Memorandum to the City of Markham Committee of Adjustment

File: A/211/23
Address: 9 Old English Lane, Markham (Thornhill)
Agent: Makow Associates Architect Inc. (Jim Pfeffer)
Hearing Date: Wednesday, May 1, 2024

1 SITEPLAN
A-000 1 : 200

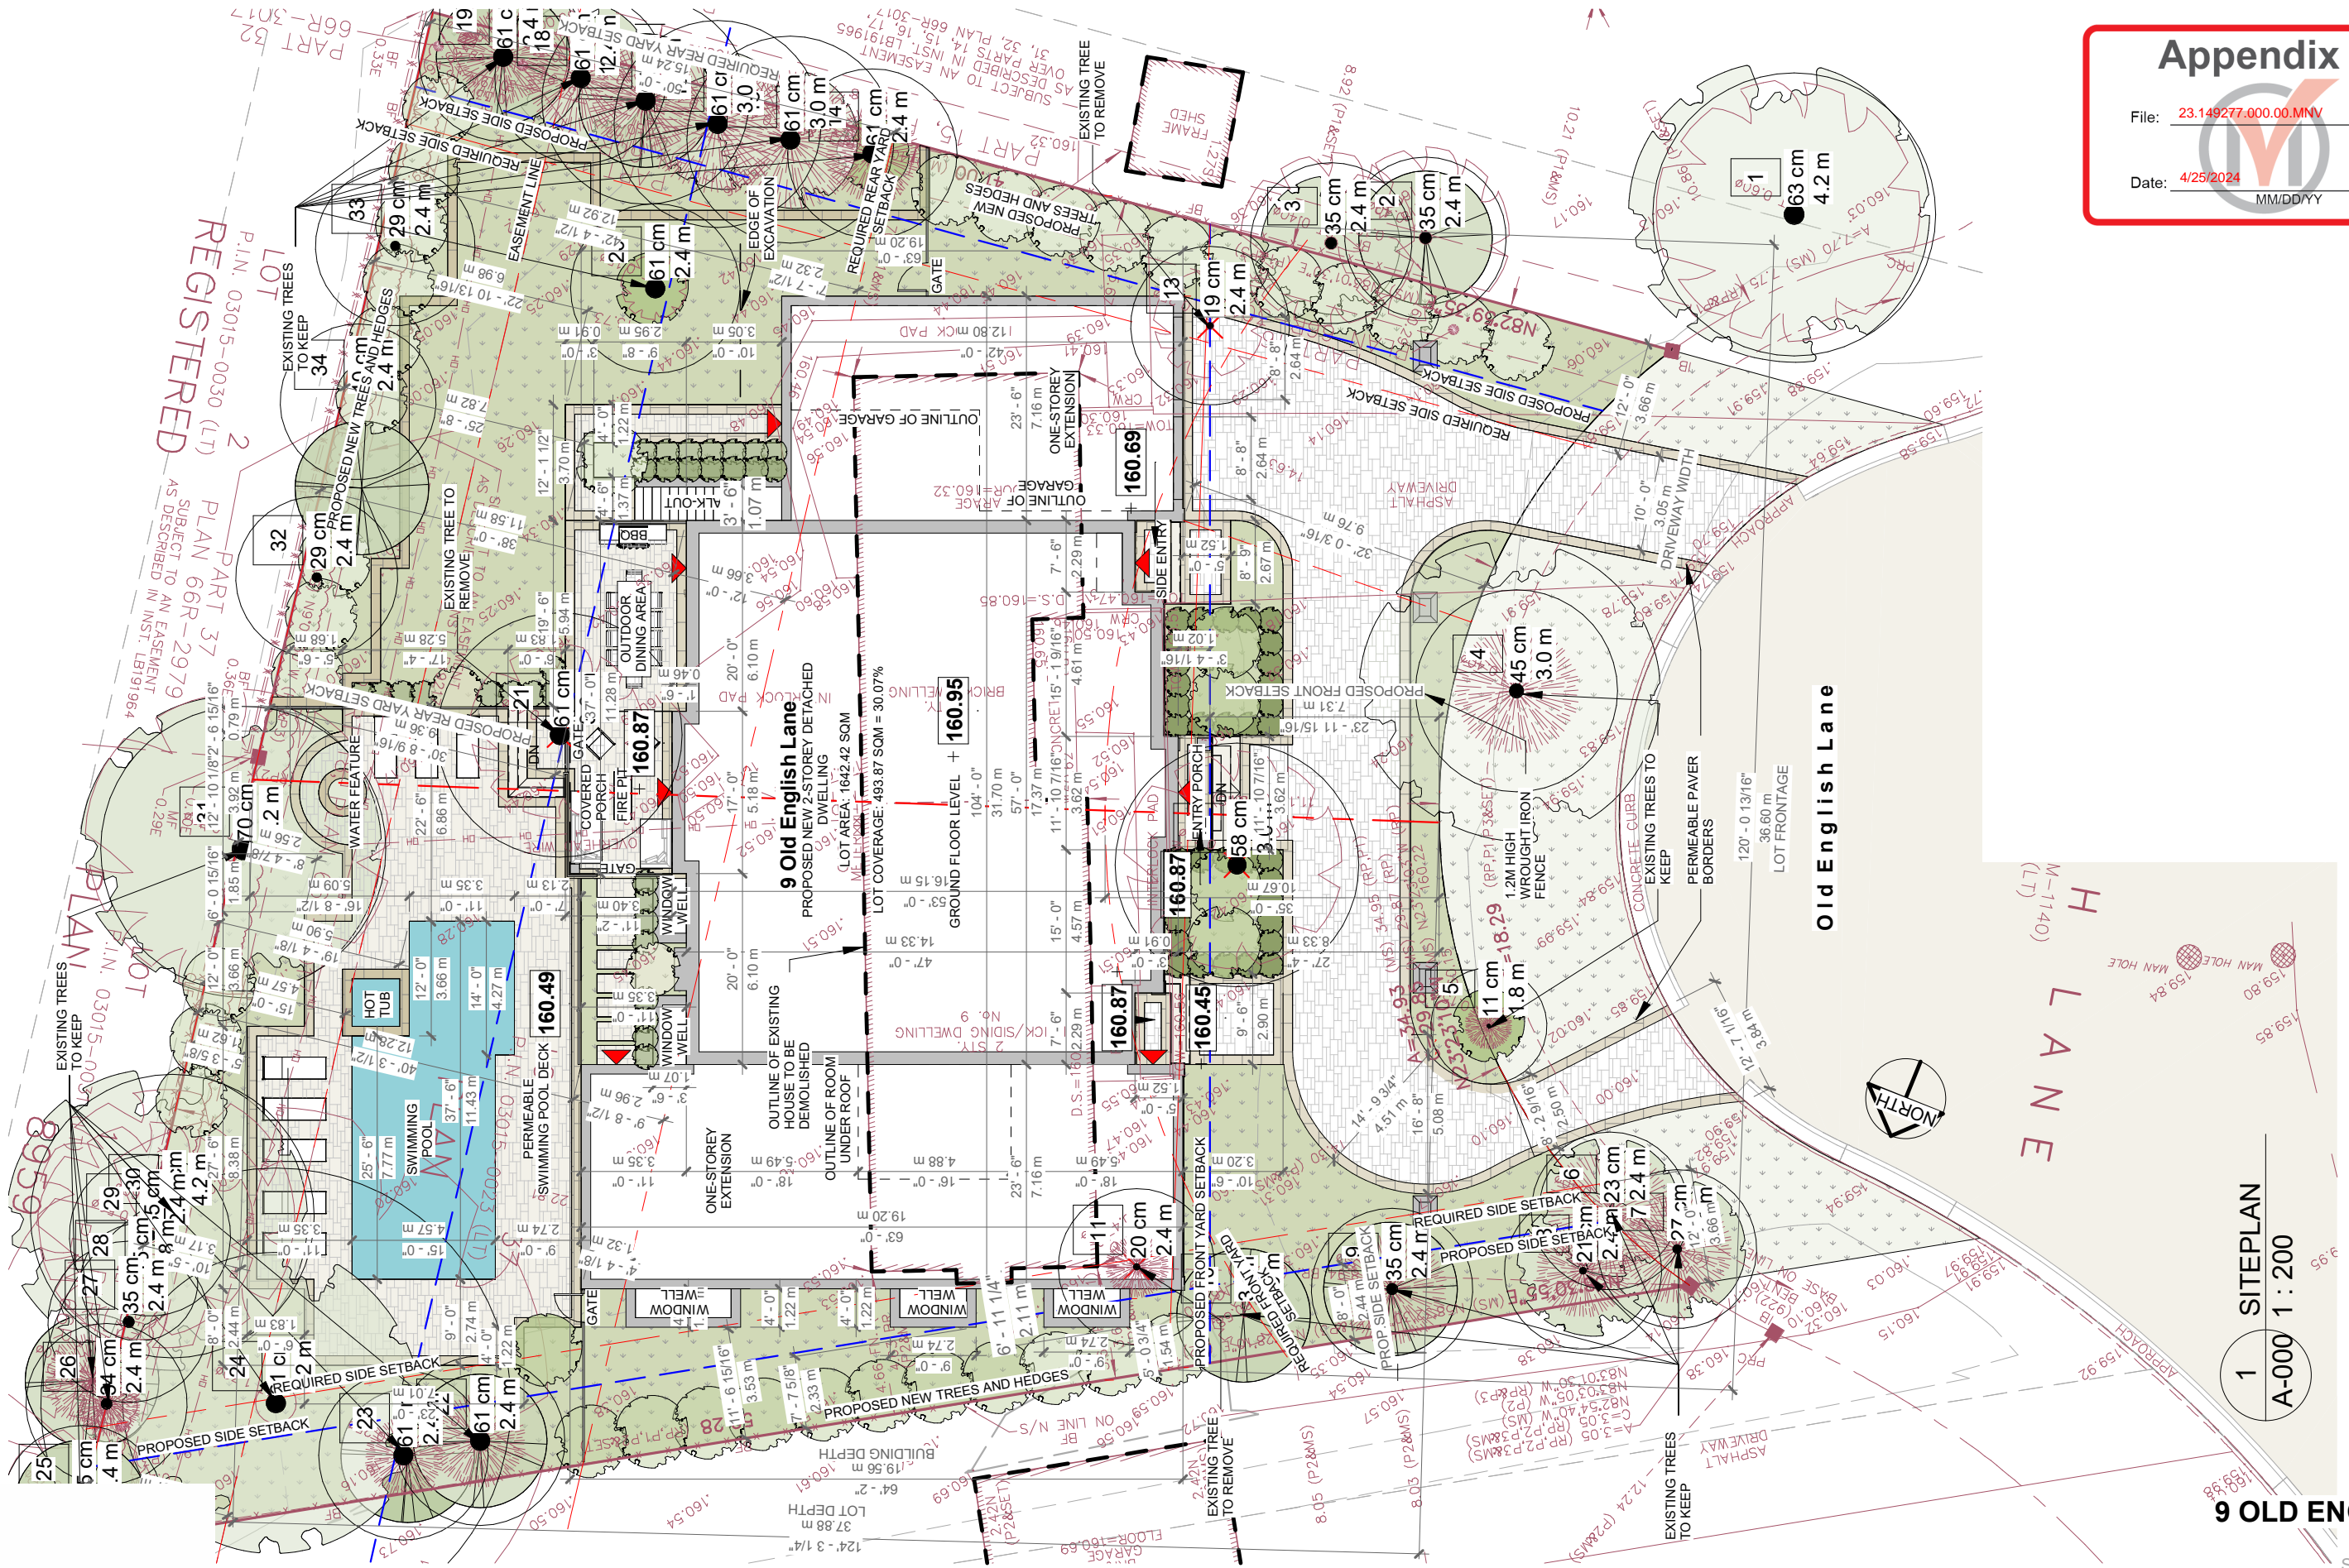
The existing driveway complies with the above criteria, except where the proposed second driveway has a width of 5.08 metres (16.67 feet) which exceeds the maximum width by 1.38 metres (4.53 feet) that is permitted under the above-mentioned Parking Standards By-law. Staff do not anticipate any adverse impacts as a result of the requested variance and are of the opinion that a reasonable balance between hardscape and soft landscaping elements in the front yard will be maintained in this instance.

The main front wall of the proposed dwelling will provide a front yard setback that is generally consistent with the established front yard setback pattern on the street. Staff are of the opinion that the proposed front yard setback is minor and have no concerns with the proposed variance.

The variance includes a rear covered porch and two (2) one storey portions on the north and south side of the dwelling which adds approximately 3.40 metres (11.15 feet) to the overall depth of the building. The main component of the building, excluding the rear covered porch, and the one-storey portions has a depth of 16.15 metres (53 feet), which complies with the By-law requirements. The requested building depth variance is entirely attributable to the proposed rear covered porch and the two (2) one storey extensions. The proposed rear covered porch consists of a north side yard setback of 12.50 metres (41 feet), and a rear yard setback of 9.36 metres (30.71 feet) and will not result in any impact to abutting properties.

The Owner is requesting relief to permit a minimum rear yard setback of 30.67 feet (9.3 metres), whereas a minimum of 50 feet (15.24 metres) is required. This represents a reduction of approximately 19.33 feet (5.89 metres). The variance is entirely attributable to the proposed rear covered porch and the main rear wall of the proposed building. The main rear wall of the proposed building provides a rear yard setback of 30.71 feet (9.36 metres). Staff note that reduced rear yard setback can be attributed to the irregular shape of the Subject Lands.

The proposed development will include a mix of trees and hedge rows densely packed along the north and south property lines which lessen the impact on the adjacent properties. Given the irregular lot shape, and surrounding context, Staff's opinion that the requested variance is minor in nature and do not anticipate any adverse impacts to the abutting properties.

1 FRONT (WEST) ELEVATION
A-200 1 : 100

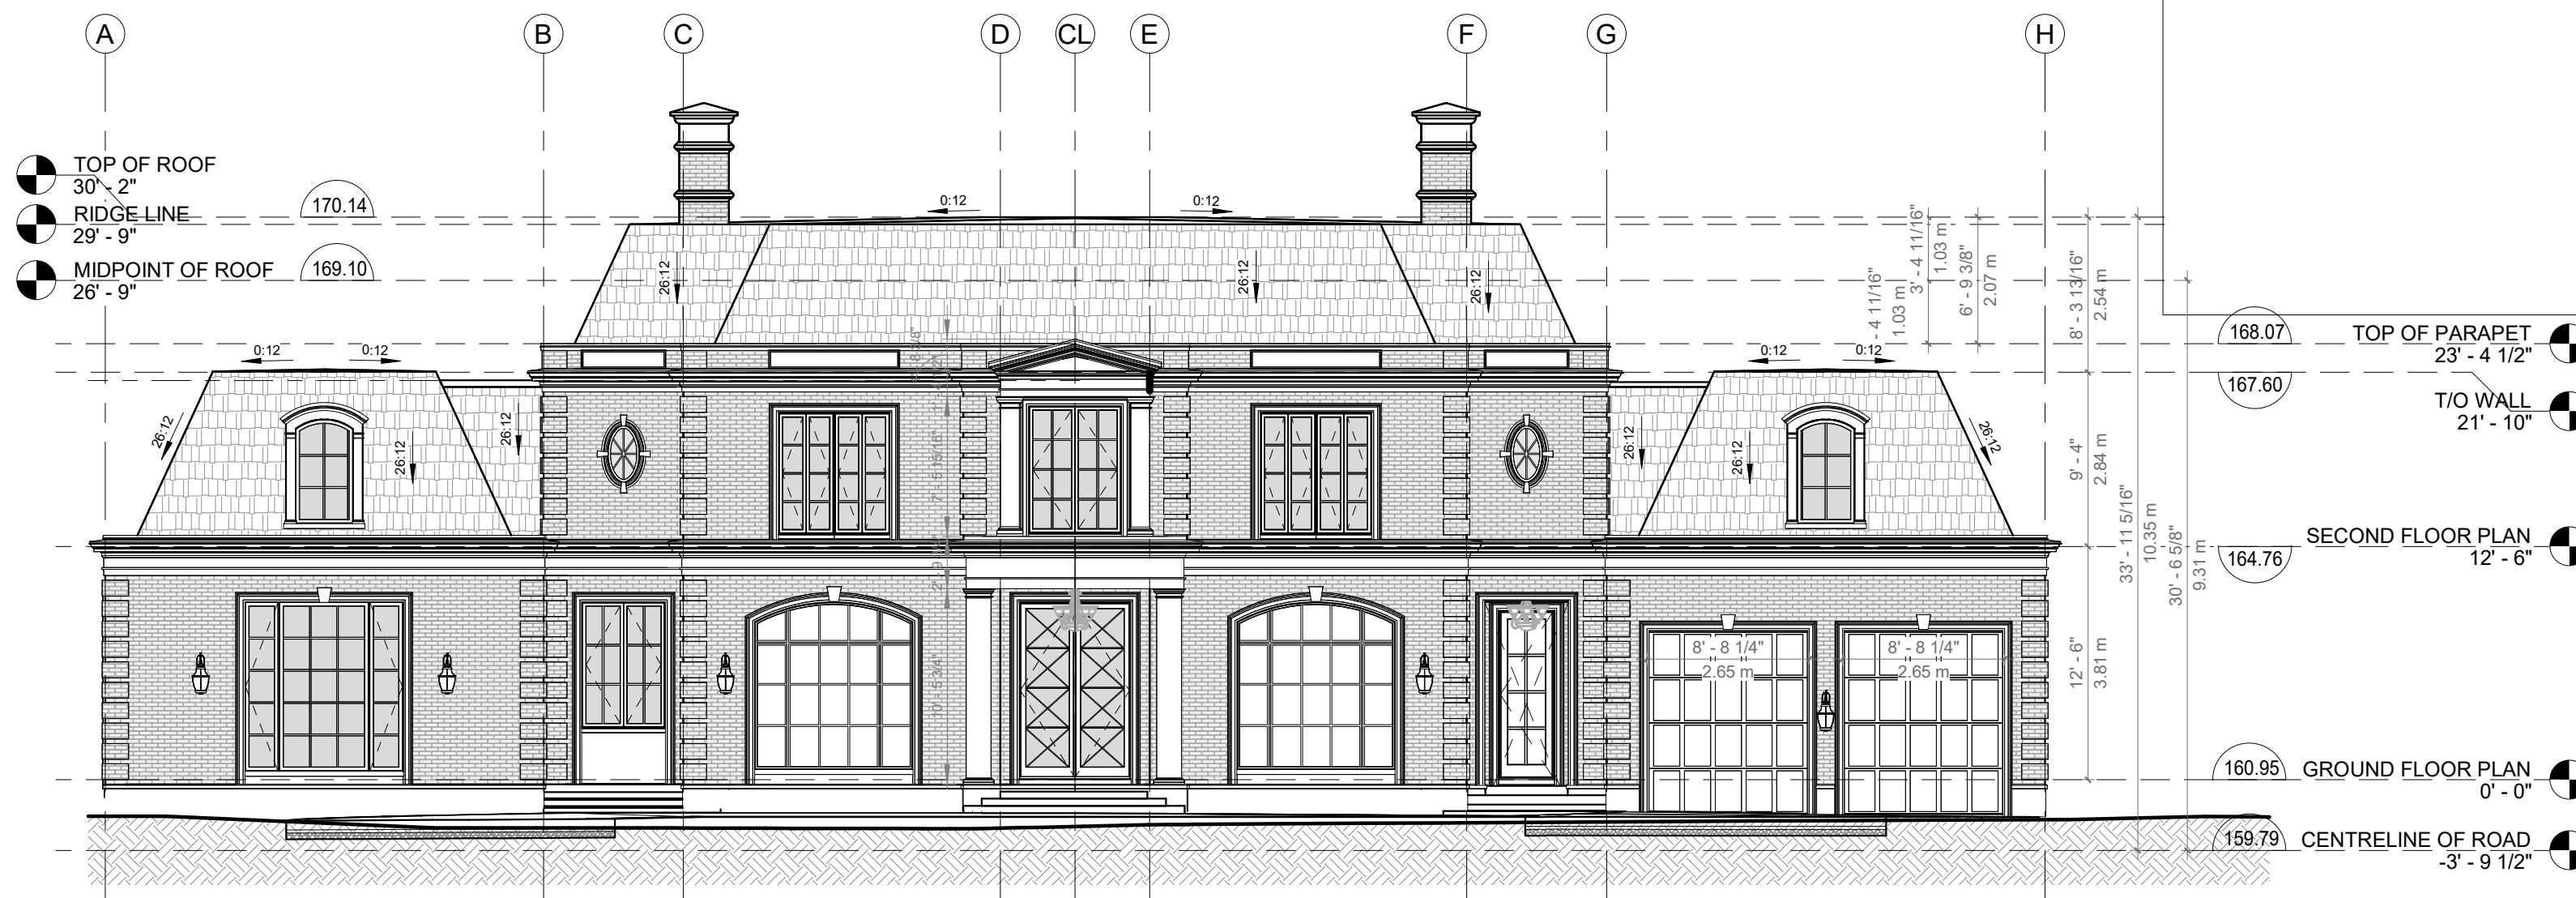
Staff are of the opinion that the proposed maximum building height is minor in nature, will have limited impact on the streetscape and therefore have no concern with the requested variance.
